APPLICATION FOR EXCEPTION - BUILDING BOARD OF APPEALS

Elizabeth Sauve the designer with Synecdoche Design Studio, has applied for an variance to the Plumbing Code section **405.3.2**. The location for this construction is at Bar Star, which is located at 220 S. Main Street. The request for the variance is to provide a common area lavatory with water closets (toilet room) compartments. This function would allow the lavatories to be placed, in a common use area.

PLAN REVISION REQUEST

Enlarged Toilet Room Plan showing interior rooms, including dimensions. Not to

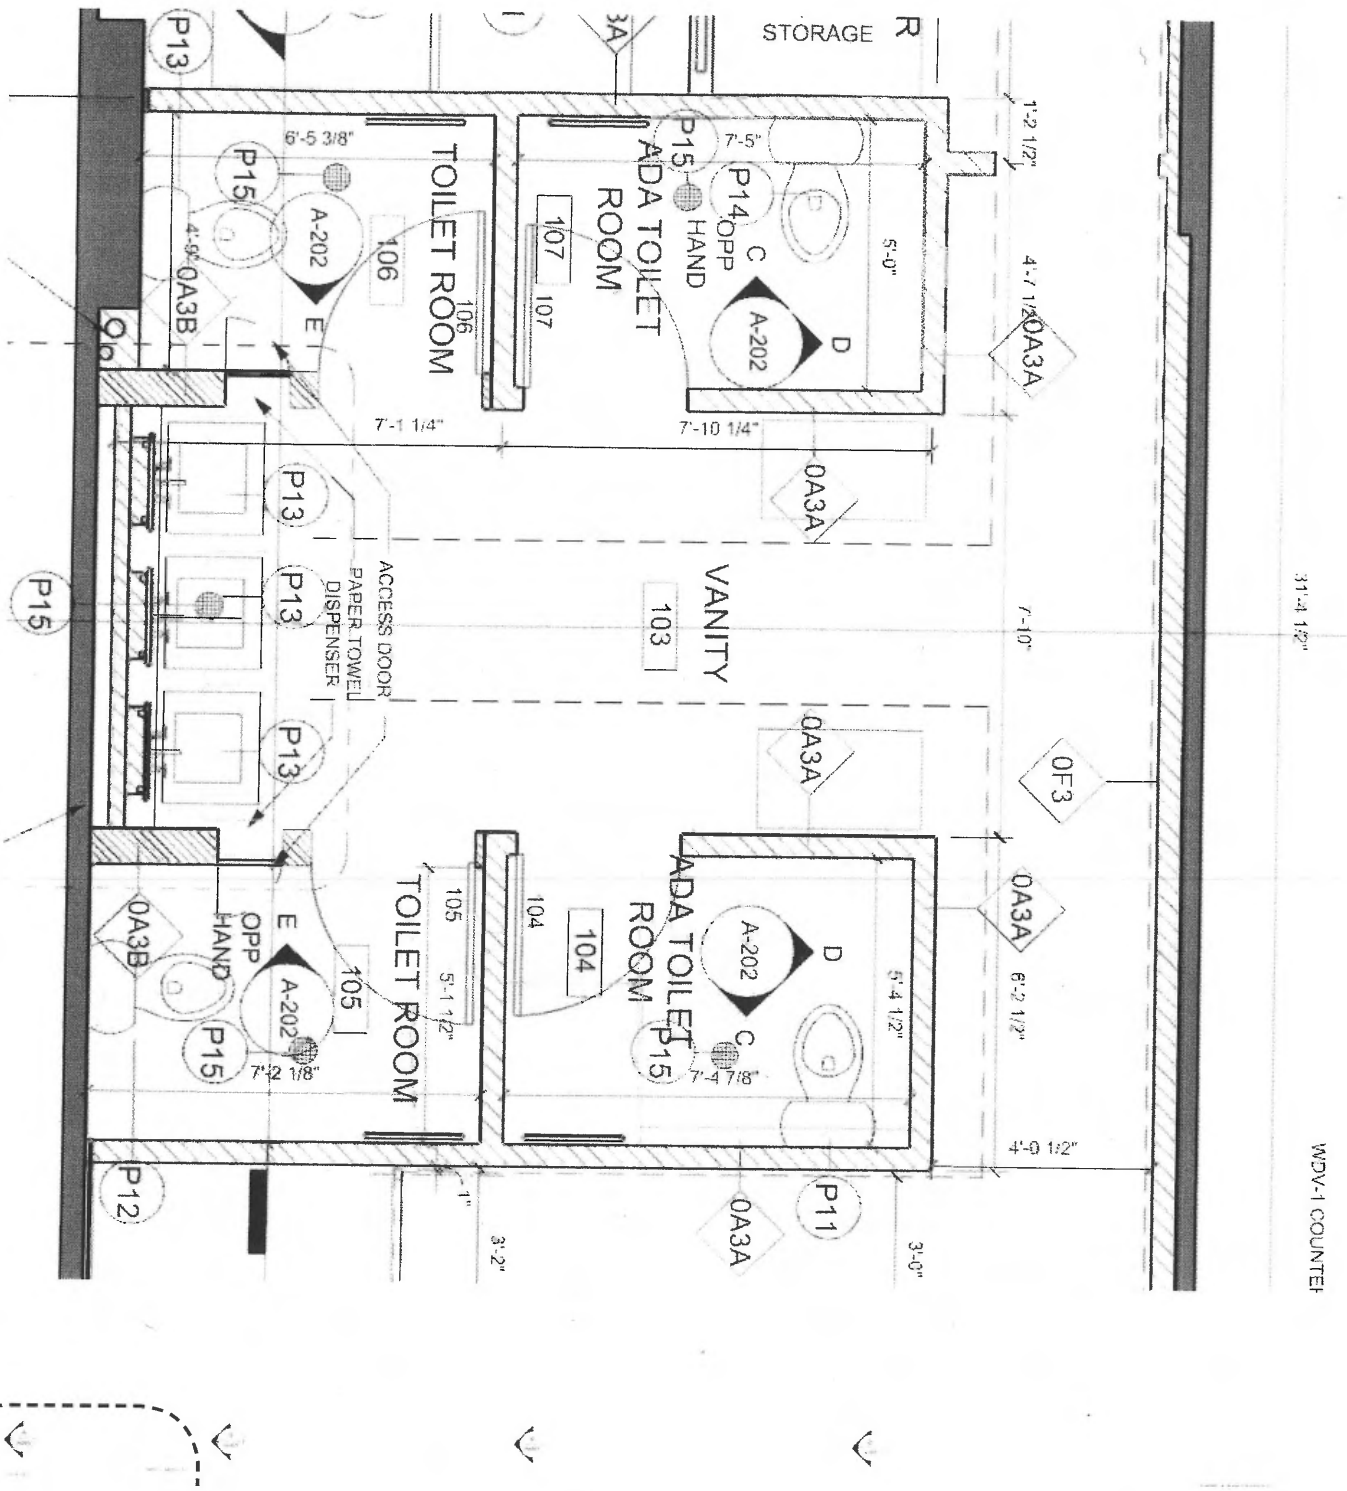
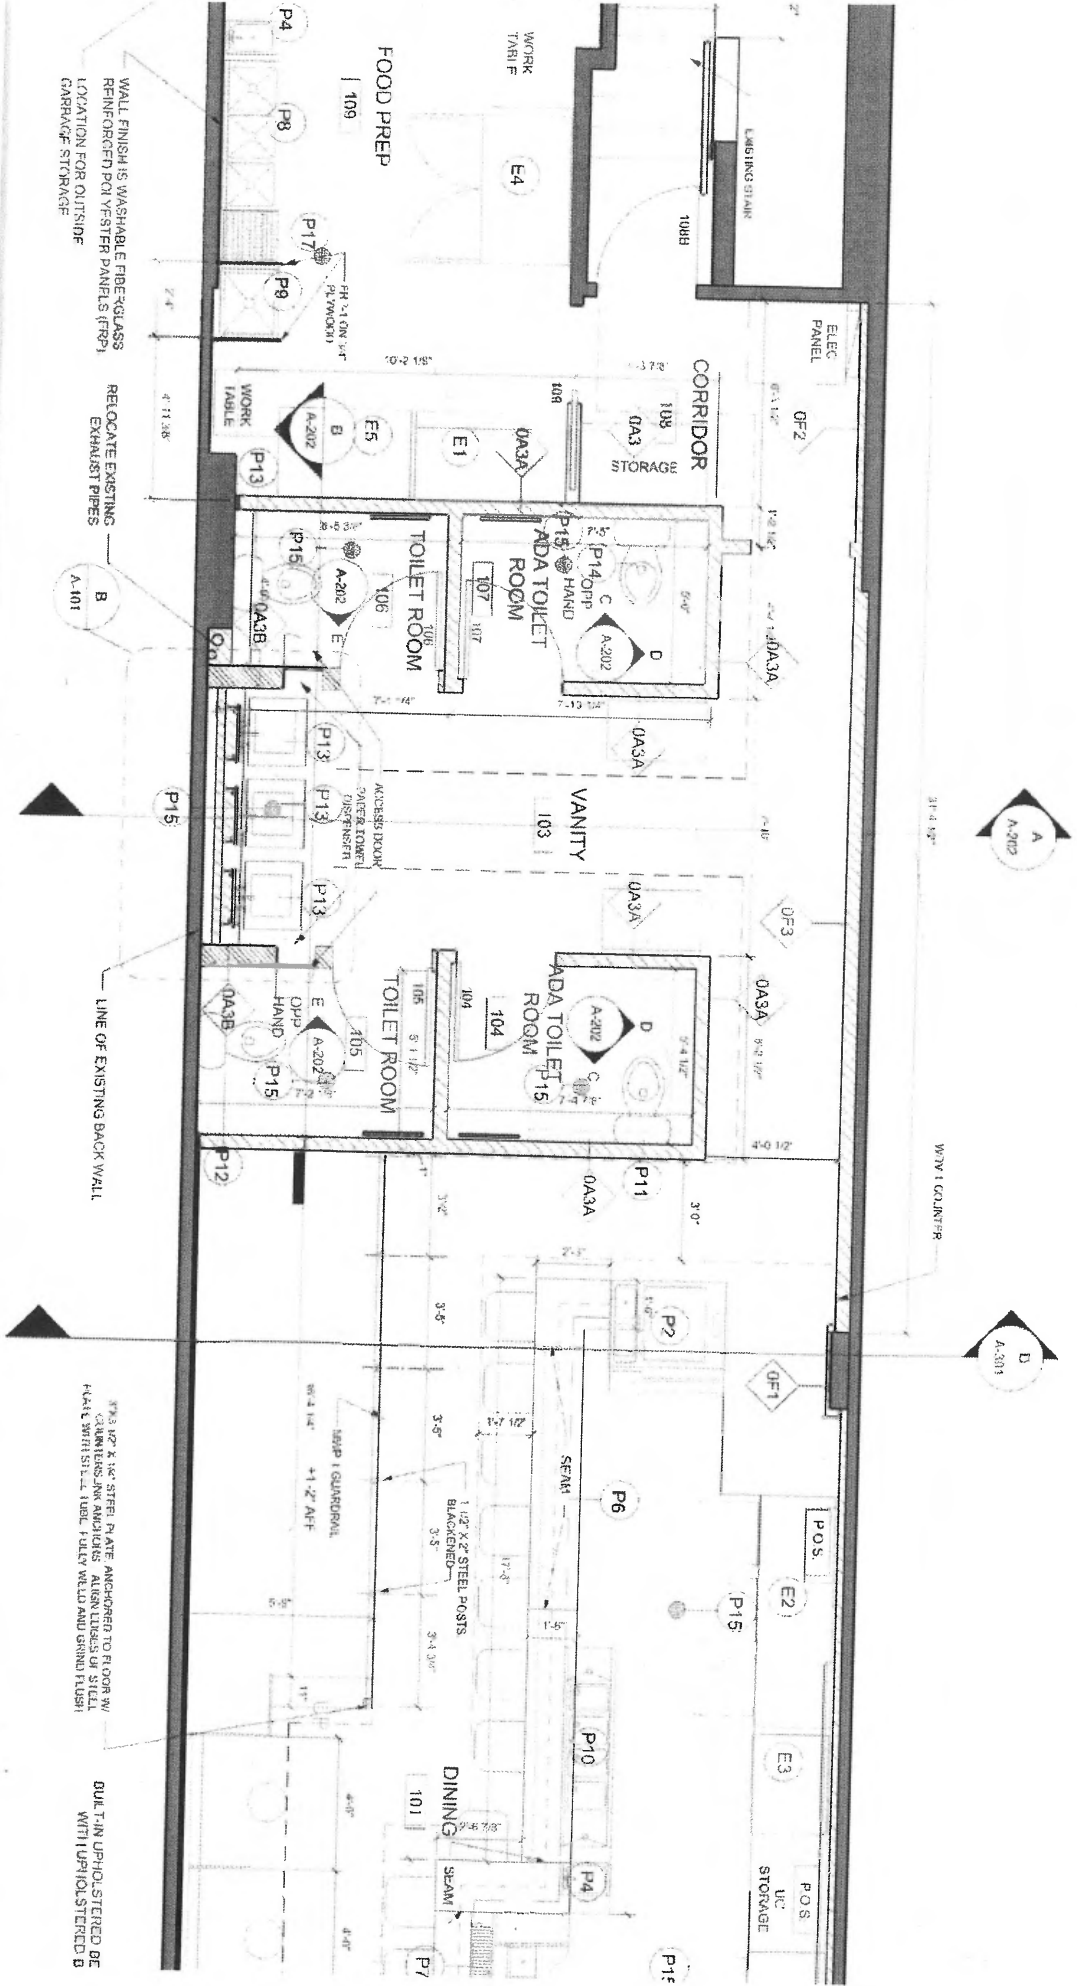
Section 1: Applicant Information		
Name of Applicant: <u>Elizabeth Sauve</u>		
Address of Applicant: <u>1342 N. Main St #5</u>		
Daytime Phone: <u>734.926.5593</u>		Fax: _____
Email: <u>Lisa@synecdochedesign.com</u>		
Applicant's Relationship to Property: <u>Designer - Synecdoche Design Studio</u>		
Section 2: Property Information		
Address of Property: <u>220 S. Main St</u>		
Zoning Classification: <u>D1 Downtown Core</u>		
Tax ID# (if known): _____		
*Name of Property Owner: <u>Gerry Spears, BarStar Ilc</u>		
<i>*If different than applicant, a letter of authorization from the property owner must be provided.</i>		
Section 3: Request Information		
<input checked="" type="checkbox"/> Exception		
Chapter(s) and Section(s) from which an exception is requested:	REQUIRED dimension:	PROPOSED dimension:
<u>405.3.2</u>	<u>Lavatory must be located in toilet room</u>	<u>Lavatory is in common room, water closet compartments are provided</u>

The Building Code requires (2) ADA bathrooms, and those facilities are provided with proper dimensions for accessible, barrier free movement. The gender neutral toilet stalls and lavatories provide additional bathrooms beyond code requirement and establish a non-discriminatory bathroom designation. There is national precedent for this arrangement for similar projects, and four examples can be found in the attachments.

T-01
A
1/4" = 1'-0"
LIFE SAFETY PLAN

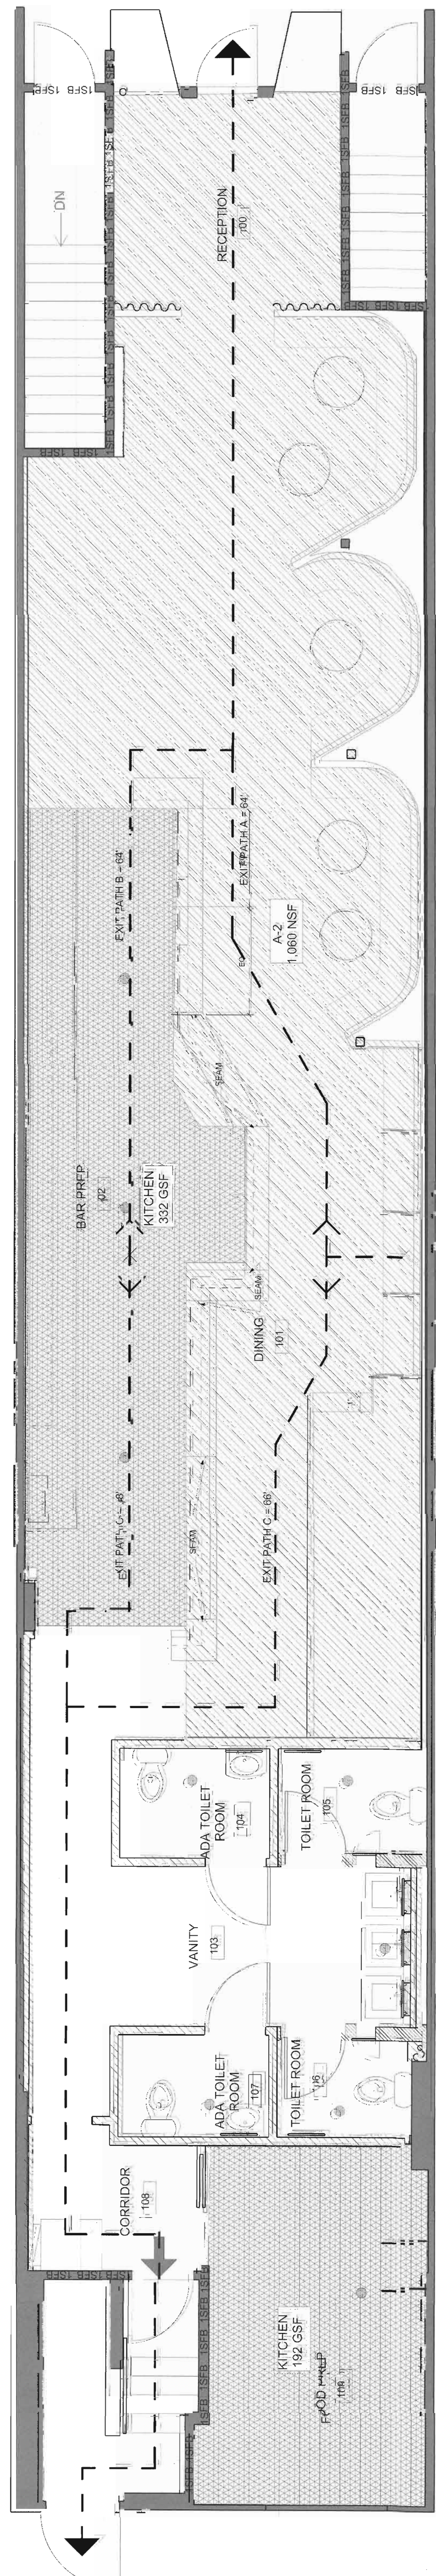
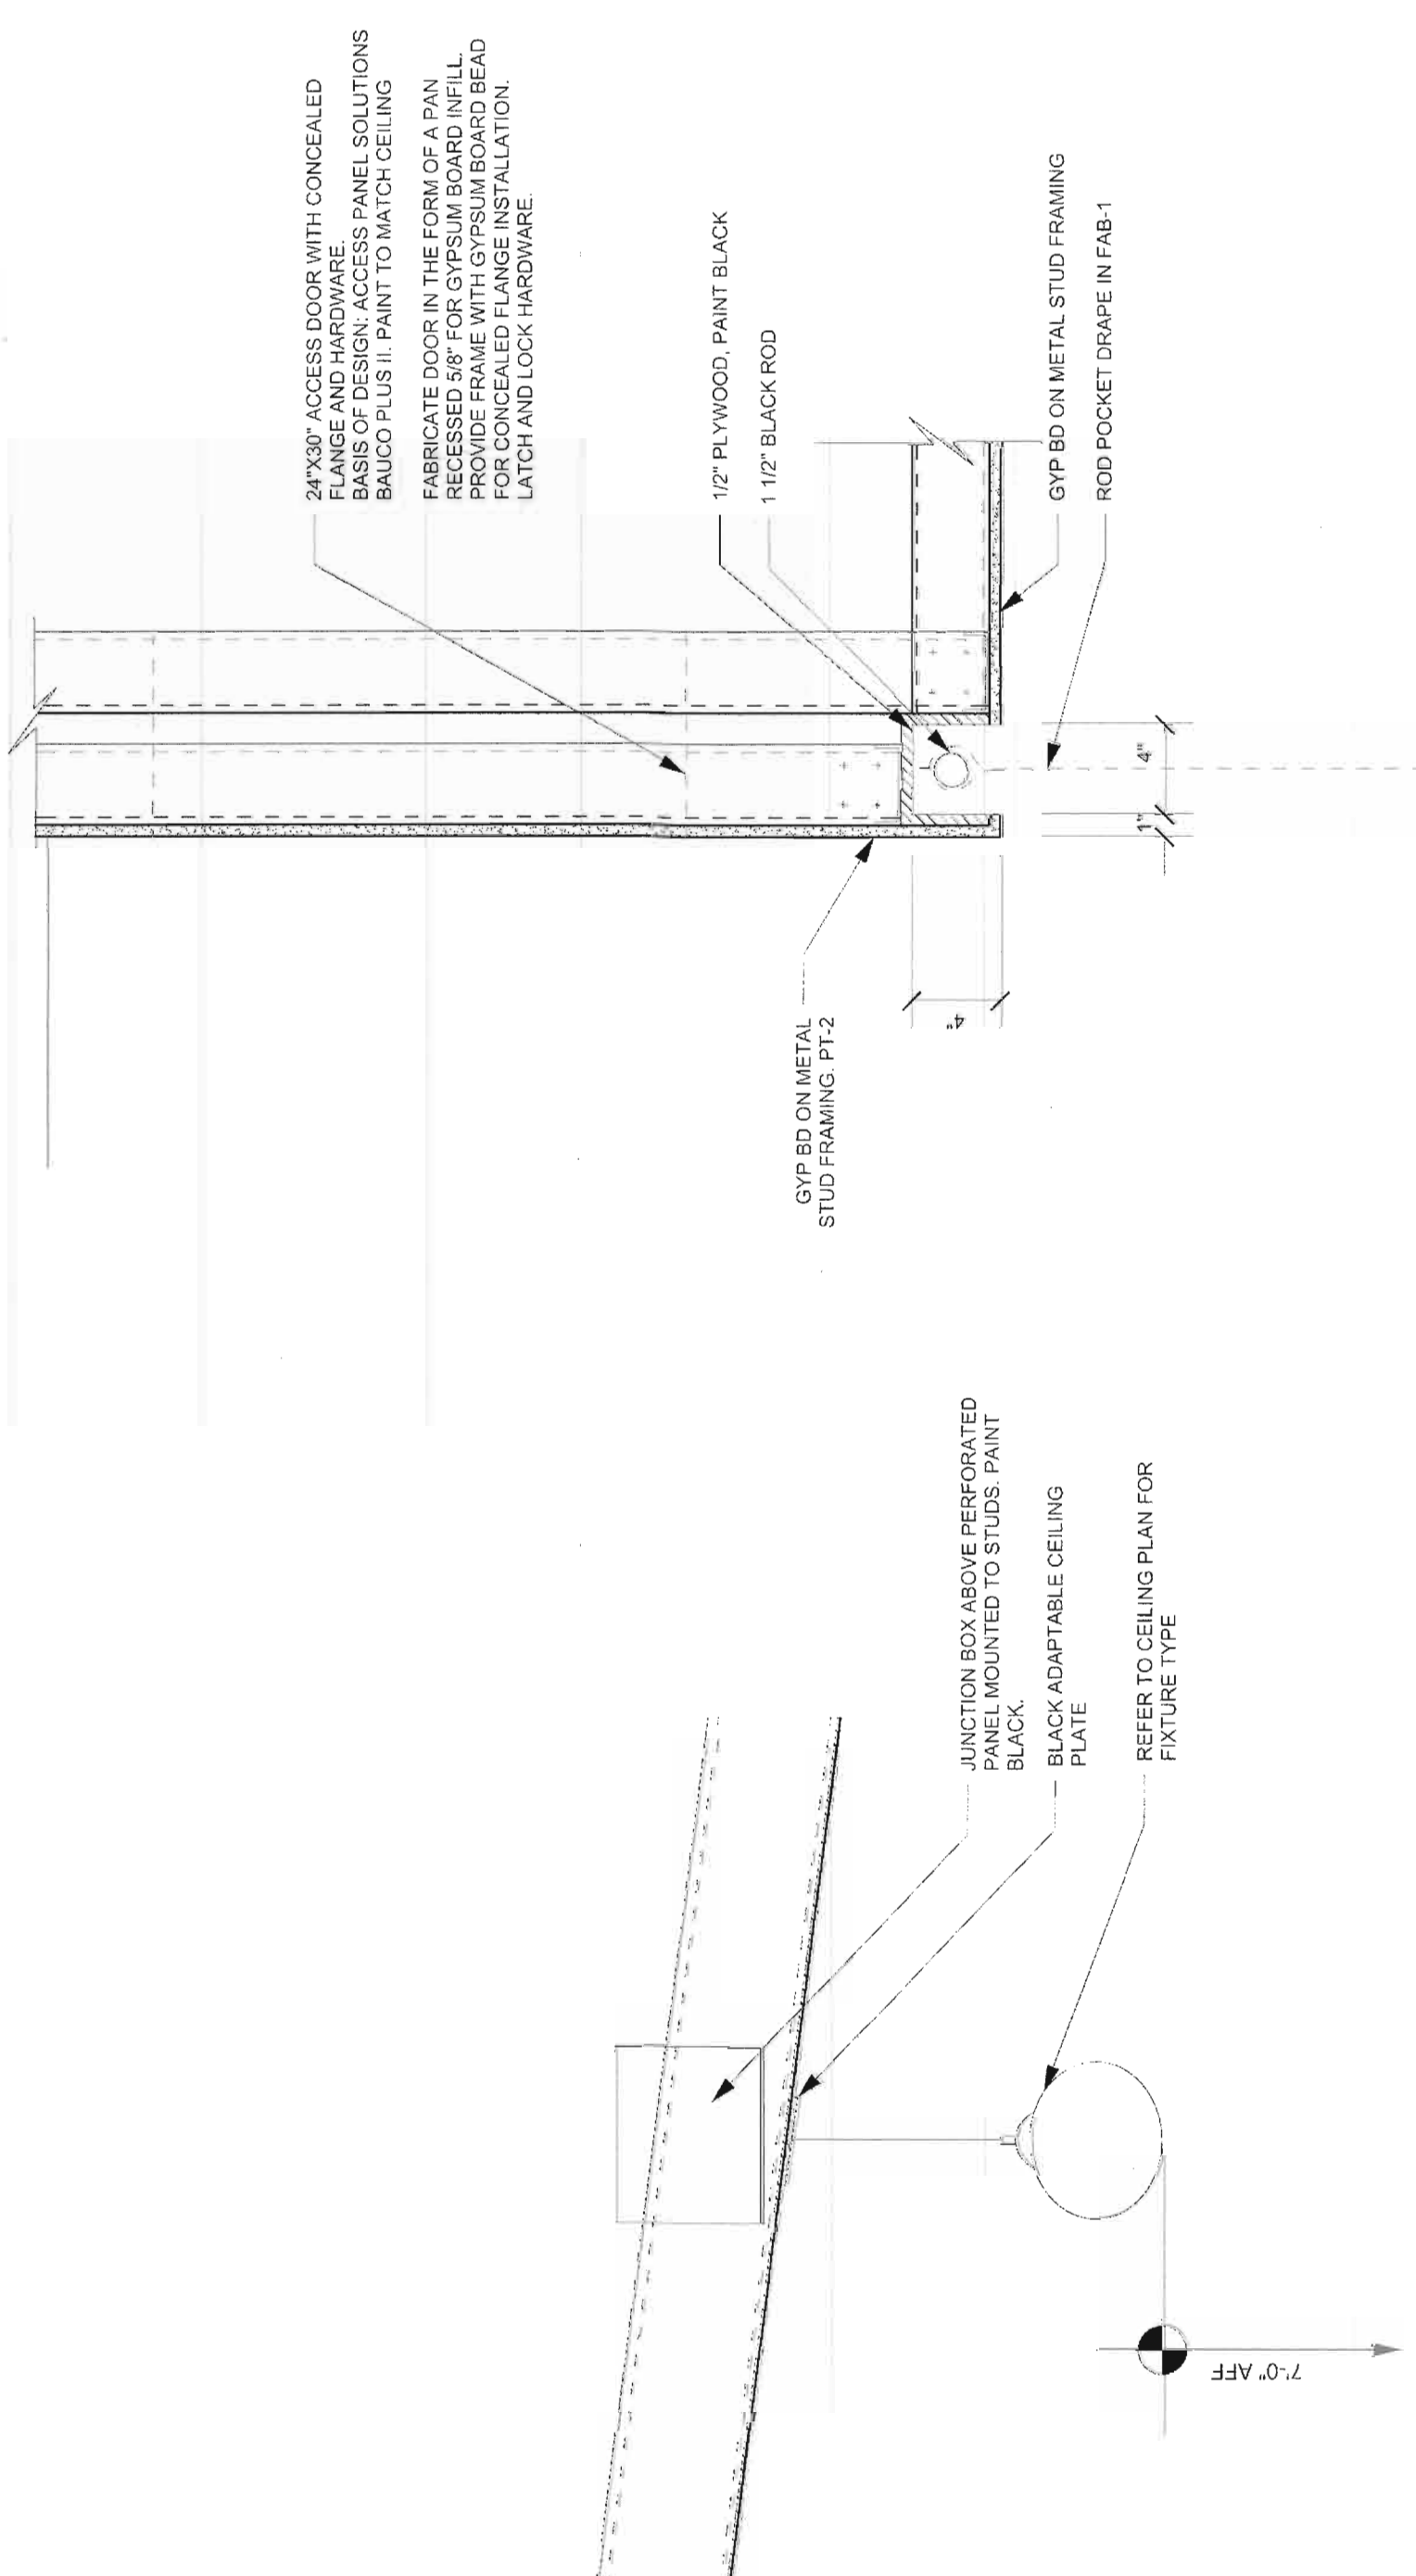
- B 706.1.1 The wall between buildings on the south side of this space is on a lot line and is used for joint service between the two buildings. The requirements for the proposed openings for HVAC equipment are similar to those recently encountered for the new third floor windows in the same building. The rules for the HVAC opening are the same as those for the windows – the code does not allow openings in this wall unless a variance is obtained from the Building Board of Appeals, or other methods of protection are used and approved by the Building Official.
- B 903.2.1.2 Please verify that the sprinkler system in the building is an NFPA 13 system providing complete building-wide coverage on all levels including the basement.

- B 1008.1.2 All doors must swing in the direction of egress travel. Door 108A must be revised so that it cannot swing against egress.
- B 1008.1.10 Egress doors serving rooms or spaces with an occupant load of 50 or more must be equipped with panic hardware or fire exit hardware.

- B 1028.10.1 The aisle dimensions in this space provide insufficient clear width. Where seating is located at a table or counter and is adjacent to an aisle or aisle accessway, the measurement of required clear width shall be made to a line 19 inches away from and parallel to the edge of the table or counter. The 19 inch distance shall be measured perpendicular to the side of the table or counter. In this space the required width must include the 19 inch required space on one or both sides depending upon the location in the space. In some cases, a total of 74 inches may be needed between counters / tables and opposite counters / tables.
-

- B1104 Provide the required maneuvering clearance at all accessible means of egress doors (ICC A117.1 – 404.2.3) .
- B 1104 Door thresholds shall be a maximum of 1/2” high with rises exceeding 1/4” beveled 1:2 (A117.1 – 404.2.4) .

P 405.3.2 The two ADA toilet rooms will have lavatories installed. All toilet rooms will remain Unisex. The doors will swing out, and the plan shows that the doors will not encroach into the required egress width by more than 7".

B1028.9 Aisle ways and their widths are marked on the plan.

B1028.10.1 Aisle ways and their widths are marked on the plan. There will be no additional seating that is not shown on plan.
